Access Compliance Report

Public Rights-of-Way

(Curb Ramps)

Intersection ID: 47613	Main Street: BATHURST_DR	Cross Street: MACQUARIE_LN	Location: NW
ADA ID: 846A90E4FD52	Ramp Type: PerpDiag	Initial Pass/Fail: Fail	Overall Compliance: No
Severity Score: 12.5

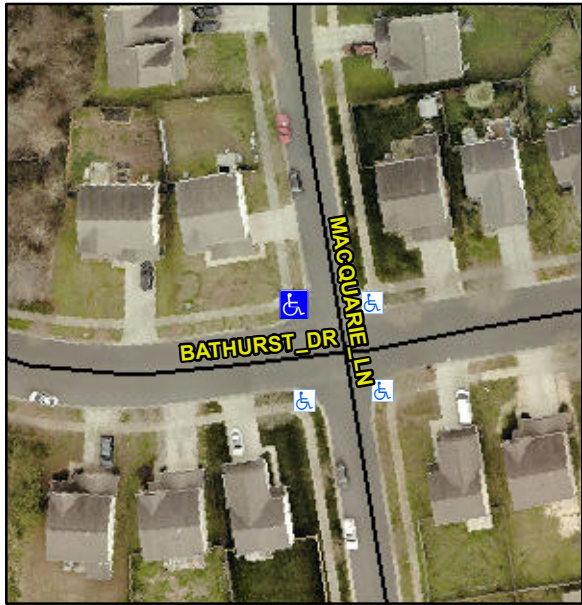
Codes/Mitigation Info/Possible Solution			Field Measurements/Component Compliance					
	Possible Solutions:		Compliance	Description	Data	Compliance	Description	Data
	Remove & Replace Curb Ramp With Two New Directional Ramps or Equivalent.		N/A	Ramp Length (in)	73.0	Yes	Ramp Slope (%)	5.5
			Yes	Ramp Width (in)	48.0	No	Ramp XSlope (%)	6.8
			N/A	Flare Type LT	N/A	N/A	Flare Type RT	N/A
			N/A	Flare Slope LT (%)	N/A	N/A	Flare Slope RT (%)	N/A
			N/A	Flare Traversable LT?	N/A	N/A	Flare Traversable RT?	N/A
			N/A	Landing Length (in)	N/A	N/A	DWS Provided?	N/A
			N/A	Landing Width (in)	N/A	N/A	DWS Contrast?	N/A
			N/A	Landing Slope (%)	N/A	N/A	DWS Length (in)	N/A
			N/A	Landing X Slope (%)	N/A	N/A	DWS Full Width?	N/A
	Surveyor Notes:		N/A	Landing Curb? (Y/N)	N/A	N/A	DWS Offset (in)	N/A
	N/A		N/A	Shared Landing?	N/A			
	PROW/ADA:		N/A	Gutter Ponding?	N/A	N/A	Gutter Slope (%)	N/A
	Not Found, R304.5.3		N/A	Gutter Lip Ht (in)	N/A	N/A	Gutter X Slope (%)	N/A

N/A	Painted X Walk1?	No	N/A	Painted X Walk2?	No
				X Walk 1 Direction	To S		X Walk 2 Direction	To E
			N/A	X Walk 1 Width (in)	N/A	N/A	X Walk 2 Width (in)	N/A
				X Walk 1 Slope (%)	0.0		X Walk 2 Slope (%)	3.3
				X Walk 1 X Slope (%)	6.6		X Walk 2 X Slope (%)	1.9
			N/A	Ramp inside XWalk1?	N/A	N/A	Ramp inside XWalk2?	N/A
			Road Slope (%)	6.0	N/A	Clear Space?	N/A	
			Road X Slope (%)	4.1	N/A	Clear Space to XWalk (in)	N/A	
		N/A	Any Obstructions?	N/A	N/A	Storm Grate/Utility Hazard?	N/A	
			Obstruction Type			Storm Grate/Utility Type		
					N/A			N/A
						Yes	Surface Condition? (G/P)	Good
		Total Cost:	\$	3200.00
